From: Olson, Greg
Sent: Tuesday, July 23, 2013 2 26 PM
To: Cherne, Curtis
Cc: Williams, Brennon; 'Chris Paige'; Olson, Greg
Subject: RE· No drainage at the Enclave apartments at 9500 Osuna Road NE ABQ 87111
Attachments: F20-D024_Enclave Apts-Private Storm Drain pdf, F20D024_GandD_27JAN1995 pdf

Curtis,
I pulled the file and reviewed the Drainage File F20-D024
The Grade and Drain plan was prepared by Jeff Mortensen & Assoc and Certified, As-Built in Jan 1995

Project	ENCLAVE APARTMENTS ALBUQUERQUE, NEW MEXICO	Date JULY, 1993
Sheet Title	GRADING & DRAINAGE PLAN

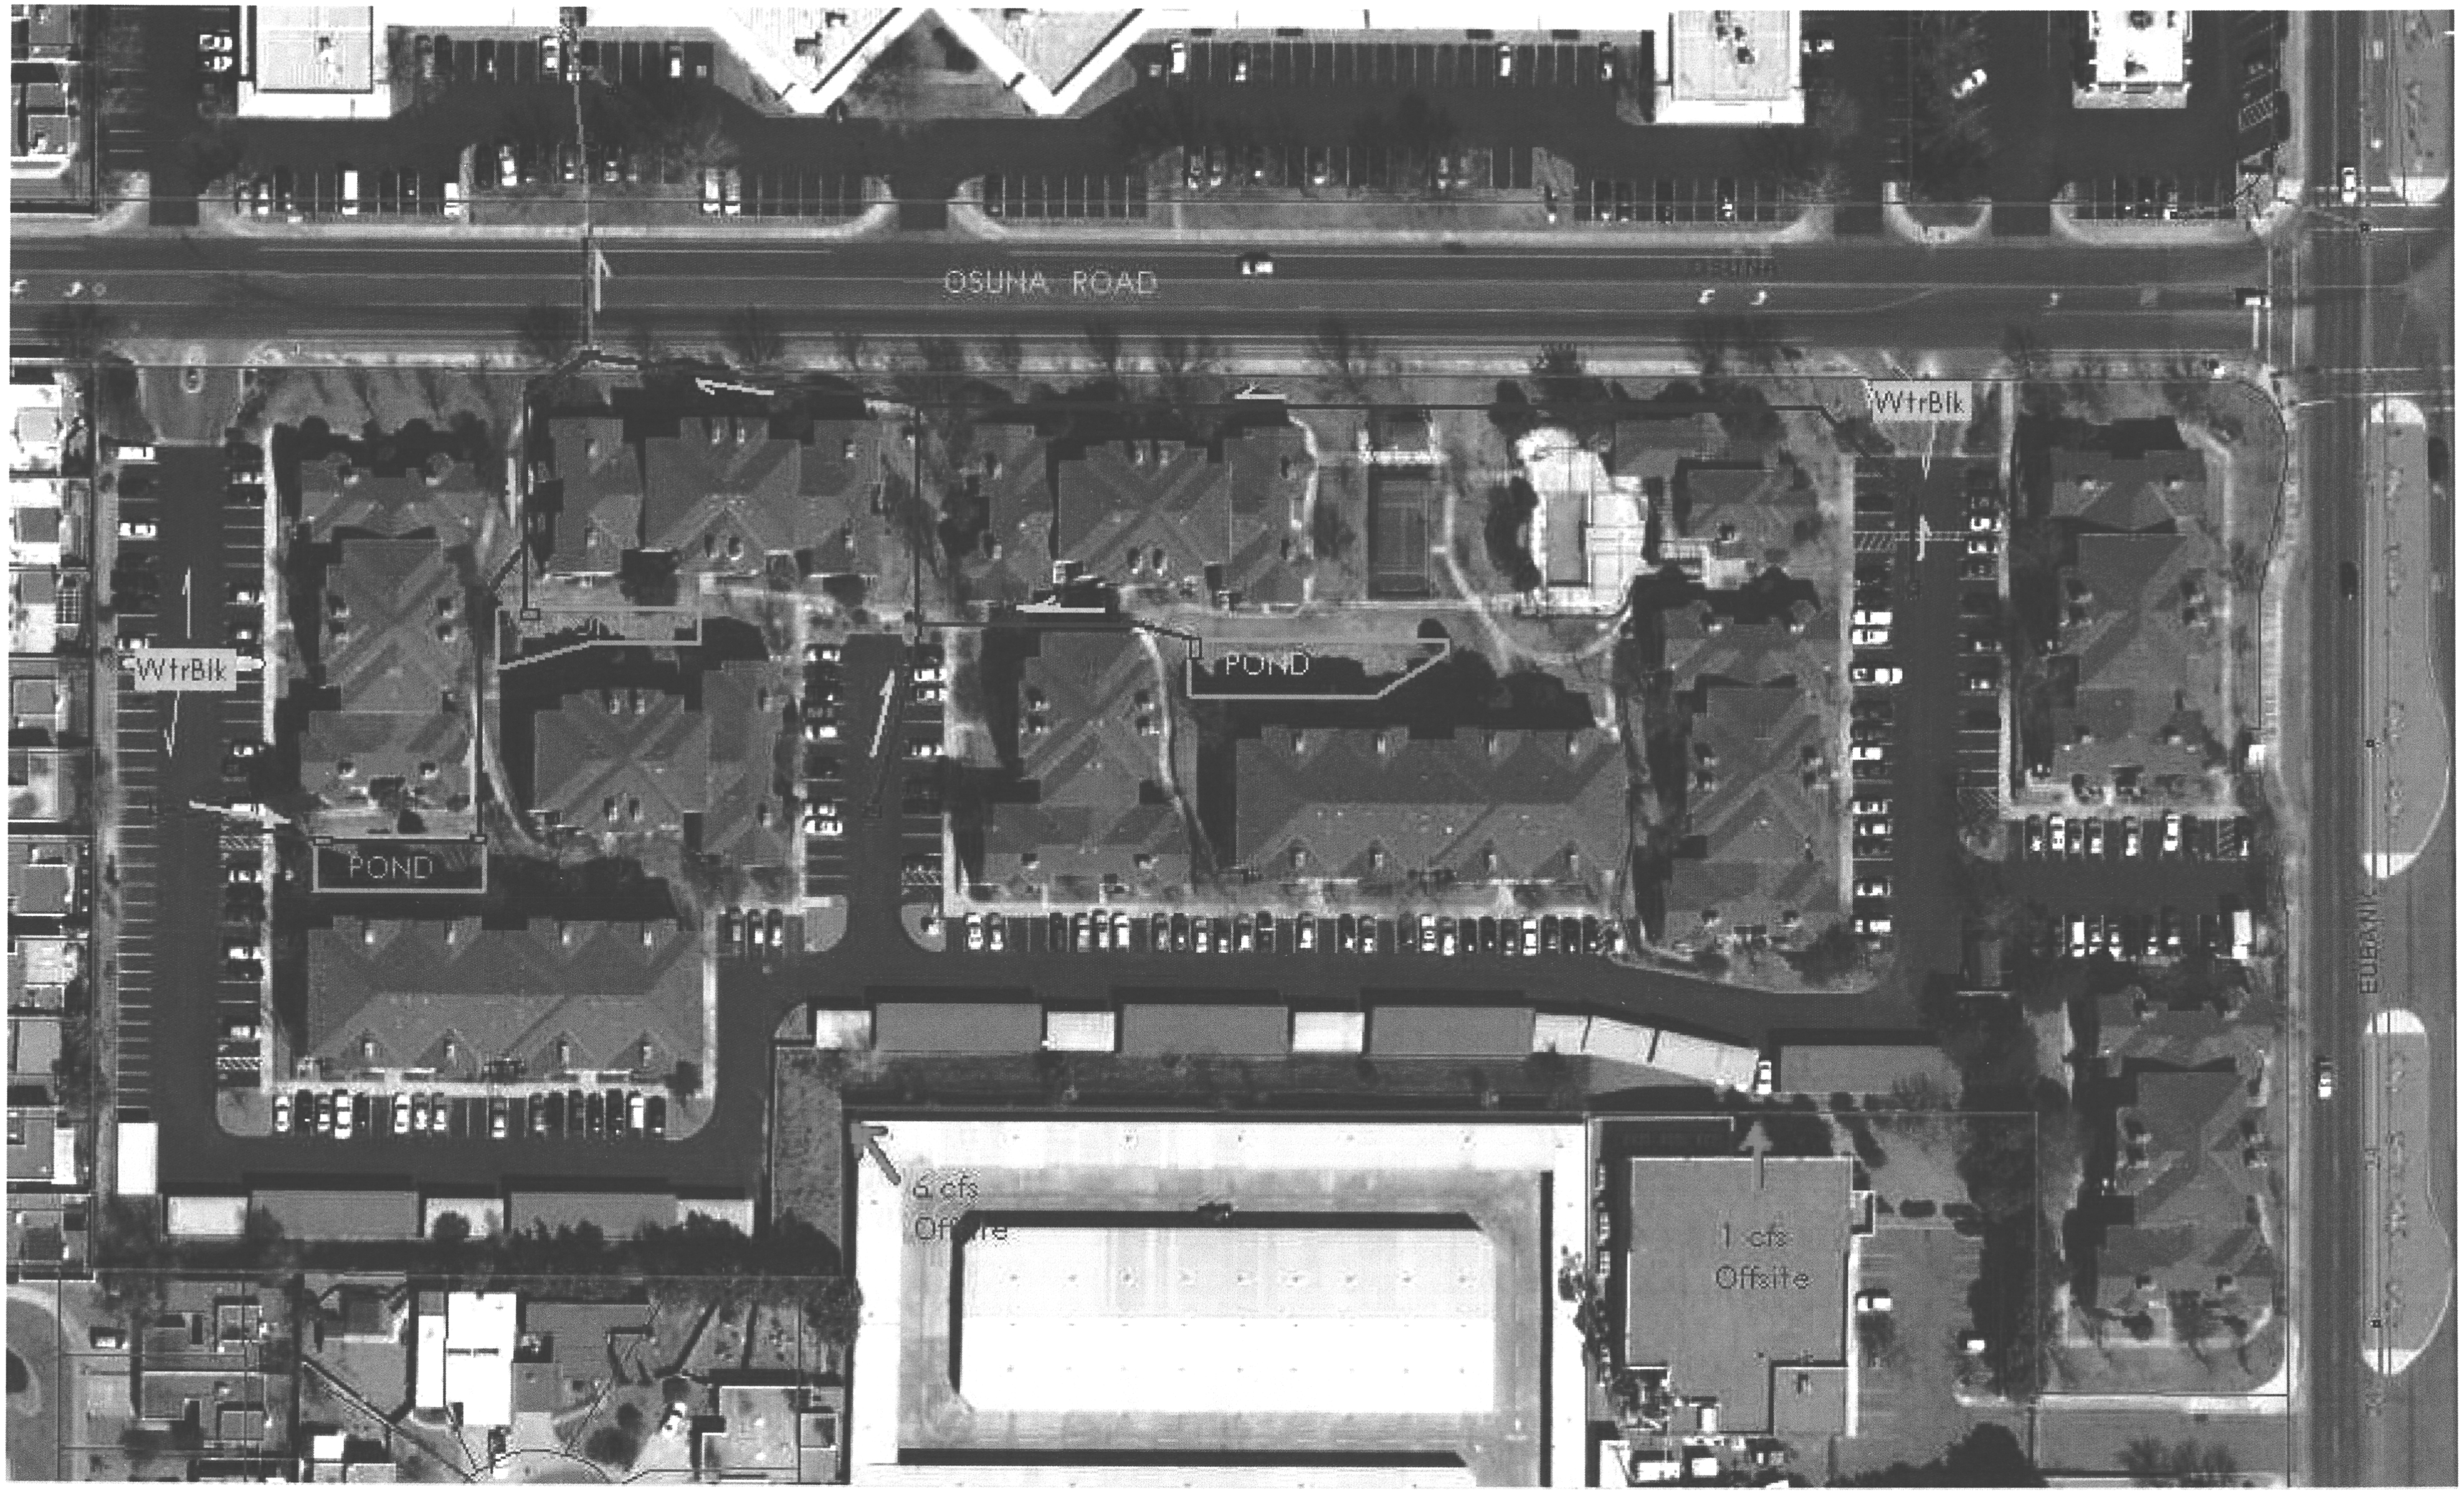
The site is required to Detain flows at 13 1 cfs maximum
The plan utilizes three ponds in Landscaped areas, similar to the photo, plus three parking lot areas, each with an orifice plate in the associated drainage inlet

Attached is a schematic layout of their private, onsite system.
Calculations on file indicate that all of the ponds should drain within about an hour of the 100-year, 6-hour storm

The pond outlet pipe have pretty small, orifice plate outlets (e g - 2 25" x 2 25" up to 4" dia.) to control the rate of release from the site If the ponds are not draining, I suspect clogging at the outlets
Management at the complex should be able to rectify by cleaning the outlets
